Well Name: POKER LAKE UNIT 28-21 BS MON	Well Location: T25S / R31E / SEC 28 / NENE /	County or Parish/State:
Well Number: 108H	Type of Well: CONVENTIONAL GAS WELL	Allottee or Tribe Name:
Lease Number: NMLC0062140A	Unit or CA Name: POKER LAKE	Unit or CA Number: NMNM071016X
US Well Number:	Well Status: Approved Application for Permit to Drill	Operator: XTO PERMIAN OPERATING LLC

Notice of Intent

Sundry ID: 2635338

**Procedure Description:** \*\*Name Change, Spacing, Casing/Cement, Drilling Variance Changes XTO Permian Operating, LLC requests permission to make the following changes to the original APD: XTO Permian Operating, LLC. requests to make this a monitoring well to collect formation pressure responses in establishing greater understanding of parent/child relationships between wellbores. This data is beneficial for Poker Lake Unit to assist in an accelerated understanding of the number of wells and spacing configurations required to optimize Federal oil and gas mineral development throughout the unit. The monitoring well will either be converted to a producer or be plugged within 5-years of drill or when downhole gauges are no longer responsive, whichever comes first. Change

13-3/8" x 9-5/8" x 5-1/2" 10M RSH-2 Wellhead  
Assembly, With T-EBS-F Tubing Head

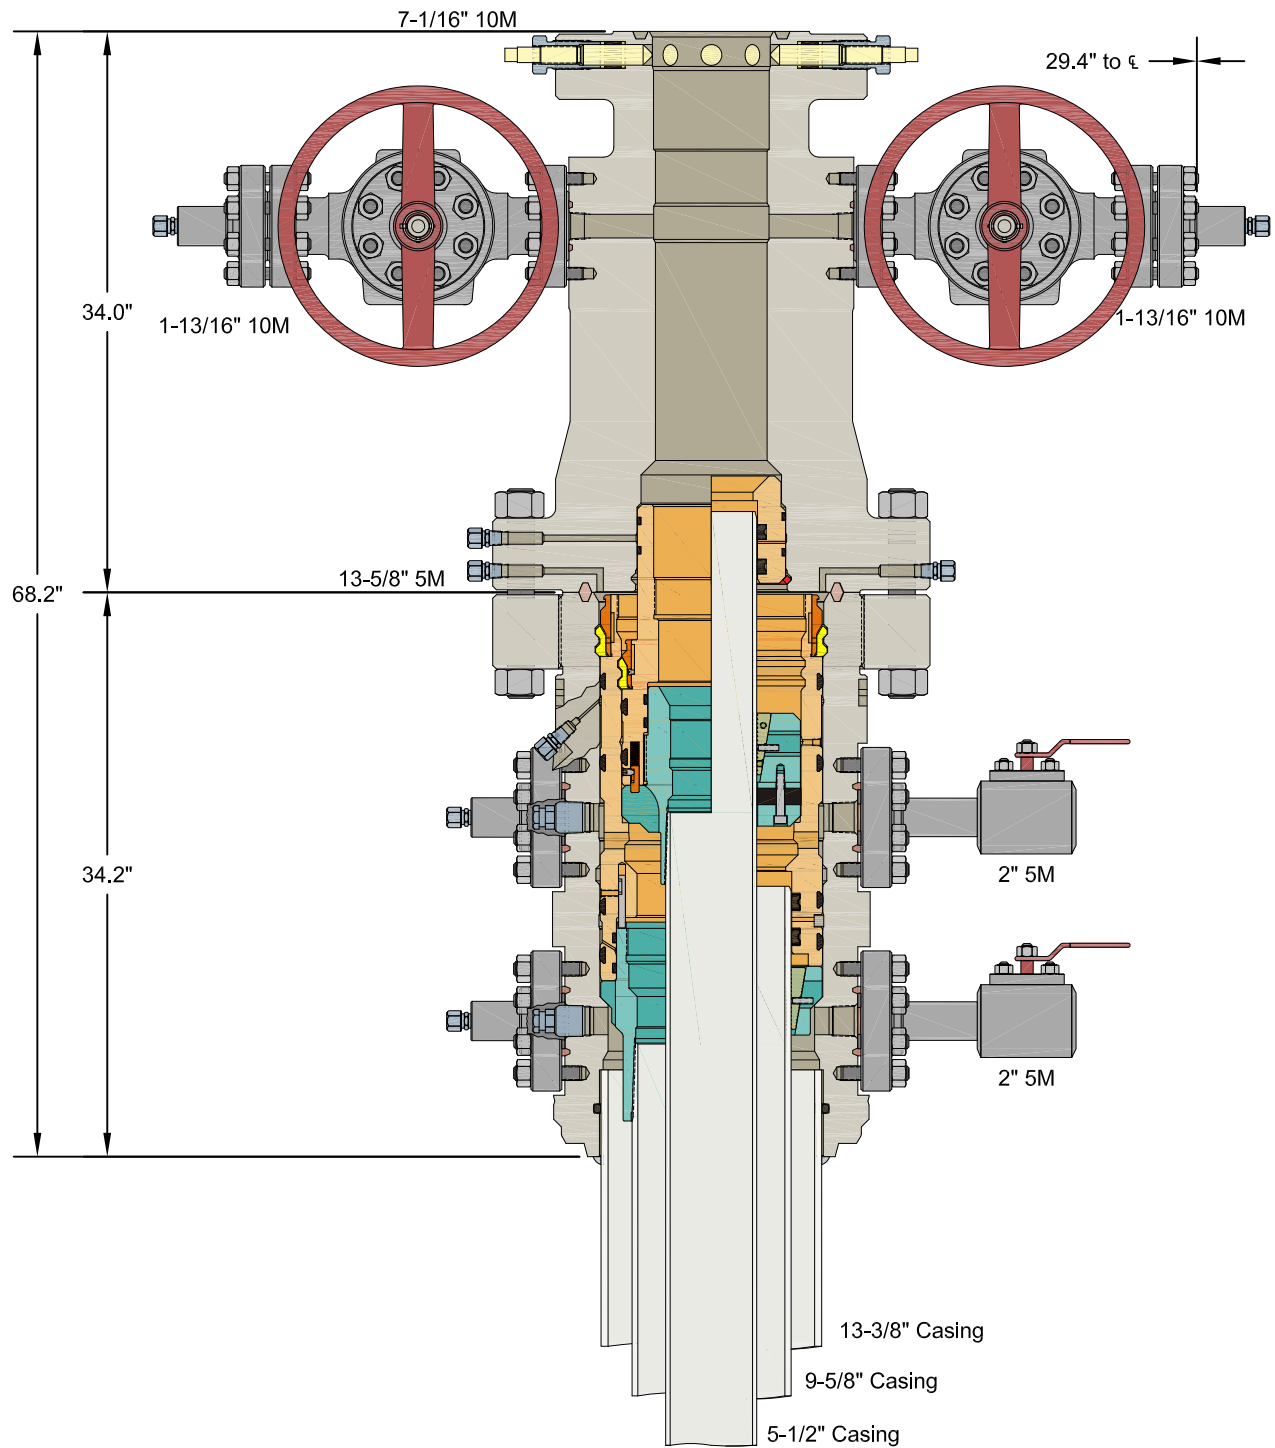
*Permanent Wellhead – Multibowl System*

A. Starting Head: 13-5/8" 10M top flange x 13-3/8" SOW bottom

B. Tubing Head: 13-5/8" 10M bottom flange x 7-1/16" 15M top flange

- Wellhead will be installed by manufacturer's representatives.
- Manufacturer will monitor welding process to ensure appropriate temperature of seal.
- Operator will test the 7-5/8" casing per BLM Onshore Order 2
- Wellhead Manufacturer representative will not be present for BOP test plug installation

1. Operator has proposed a multi-bowl wellhead assembly. This assembly will only be tested when installed on the surface casing. Minimum working pressure of the blowout preventer (BOP) and related equipment (BOPE) required for drilling below the surface casing shoe shall be **5000 (5M)** psi.

- a. Wellhead shall be installed by manufacturer's representatives, submit documentation with subsequent sundry.
  - b. If the welding is performed by a third party, the manufacturer's representative shall monitor the temperature to verify that it does not exceed the maximum temperature of the seal.

- c. Manufacturer representative shall install the test plug for the initial BOP test.
  - d. If the cement does not circulate and one inch operations would have been possible with a standard wellhead, the well head shall be cut off, cementing operations performed and another wellhead installed.
